## CONDITIONS OF APPROVAL:

## Engineering - PUD Plan Checklist

**1. Central Drive Connection to Section 37**

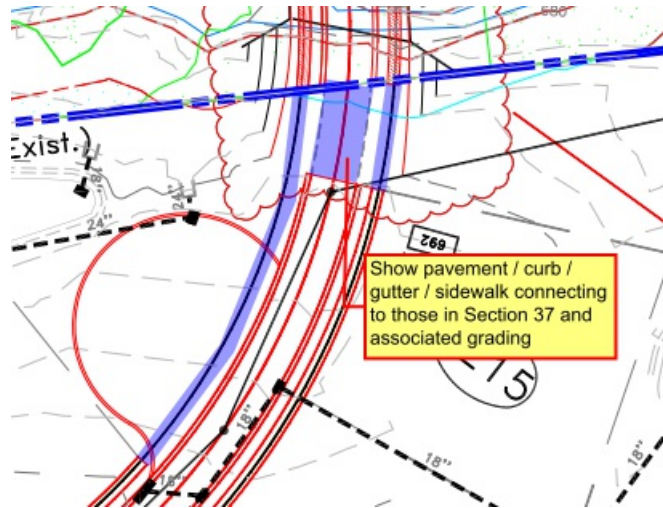
[joe.marlo@franklin.tn.gov](mailto:joe.marlo@franklin.tn.gov) Applicant has not adequately addressed the comment. Contour labels have been modified, which was not the intent of the comment. A gap in the drive to Section 37 is still shown.

Applicant to show that Central Drive is intended to be physically connected to that in Section 37 (pavement, curb/gutter, sidewalk, etc.) and show the associated grading required for this connection, similar that that shown on the opposite side of Central Drive to Section 33. The intent is to show a continuous drive with this PUD.

**3. Existing Grading**

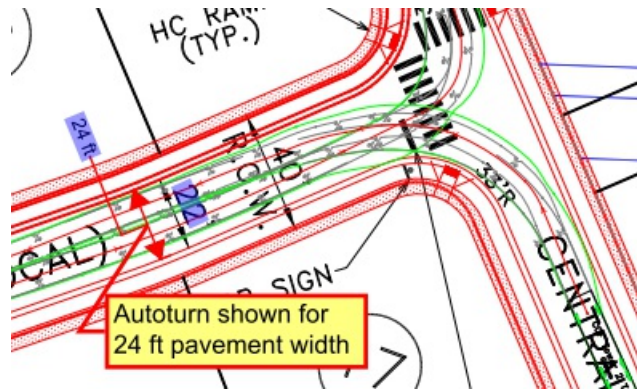
[joe.marlo@franklin.tn.gov](mailto:joe.marlo@franklin.tn.gov) This is a new comment based on new information on the drawings.

The existing grading shown on Sheet C1.1 does not match that shown on the previous review cycle and appears errant. Applicant to correct the existing grading.
